Product Change Notice (PCN)

PCN Number: PCN-0451165R-01

Product(s) Affected: PJ-041H

Reason(s) for Change: Manufacturing process improvements

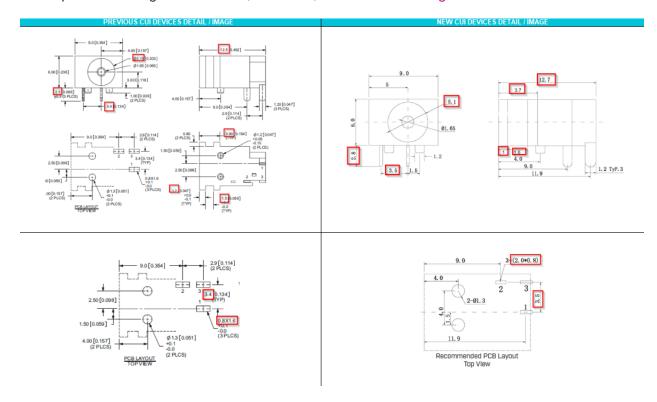
Description of Change: Mechanical, electrical, and material changes as shown below:

MATERIAL	PLATING
center pin	brass	silver
terminal 1	brass	silver
terminal 2	copper alloy	silver
terminal 3	brass	silver
plastic	PA66

DESCRIPTION	MATERIAL	PLATING/COLOR
center pin	brass	silver
terminal 1	brass	silver
terminal 2	C5191 phosphor bronze t=0,30	silver
terminal 3	C5210 brass t=0.30	silver
housing	PA66 (UL94V-0)	black
